Positron Source Estimate

Peter H. Garbincius Positron Source Meeting DESY-Zeuthen, Berlin by WEBEX – April 7, 2008

filename: PHG_Positron_Source_Estimate_7april08.ppt

JohnS: ILC Positron Systems RDR Costs

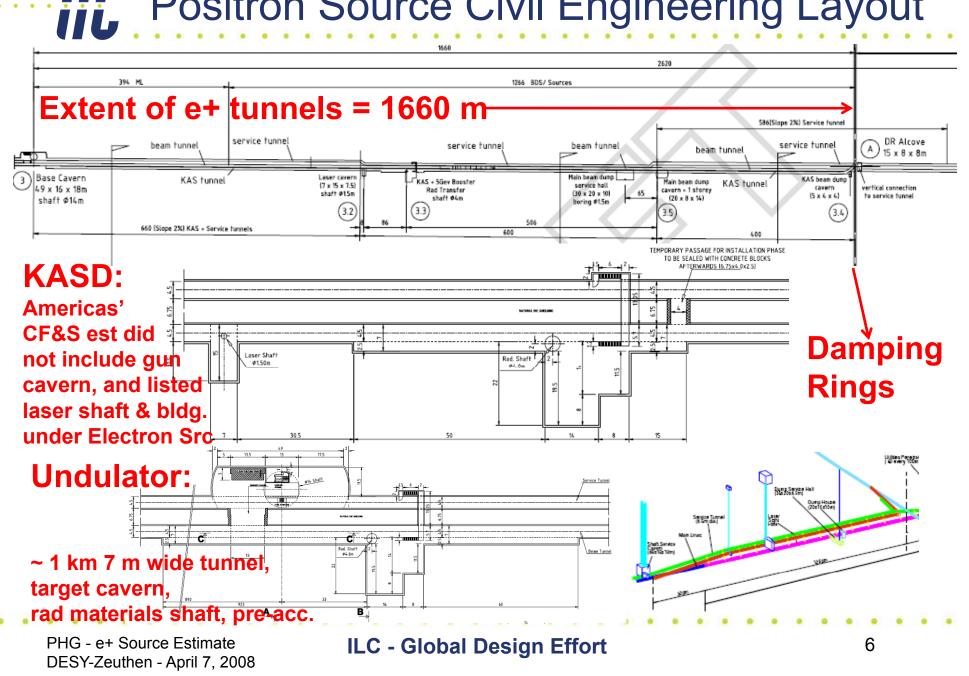
Civil:	
Und Insert:	yield and capture efficiency
	undulator strength, K^2
	electron emittance dilution
KAS Source:	~14% of total system cost
	~21% of total component cost
	is this needed? why?
	eliminate or defer
Process Water:	what is this and why?
Magnet PS:	PS are x2 cost of magnets
	excessive cable plant

Remote handling is not sufficiently accounted in RDR (\$\$\$)

Installation is possibly too low, certainly not well understood in terms of full picture (acquisition, inspection, warehousing, checkout,.....) (\$\$)

Civil allocations not well understood (caverns, shafts, timing insert,....) likely more of an accounting issue

Agreed! If not included in targets, it's not included at all!

Agreed! Installation needs much better understanding.

Nope: pretty much what Positron Source said it needed! KAS may not be needed but ILC may want something for commissioning, e- on e-, and gamma-gamma

Management decision on whether KAS is needed & current

Includes cryo plant costs for operation independent of ML

Conventional System Power - MW

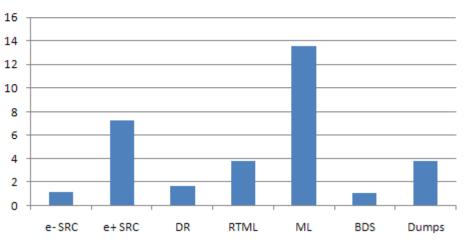
As far as I can tell, "conventional" means electronics racks and infrastructure components.
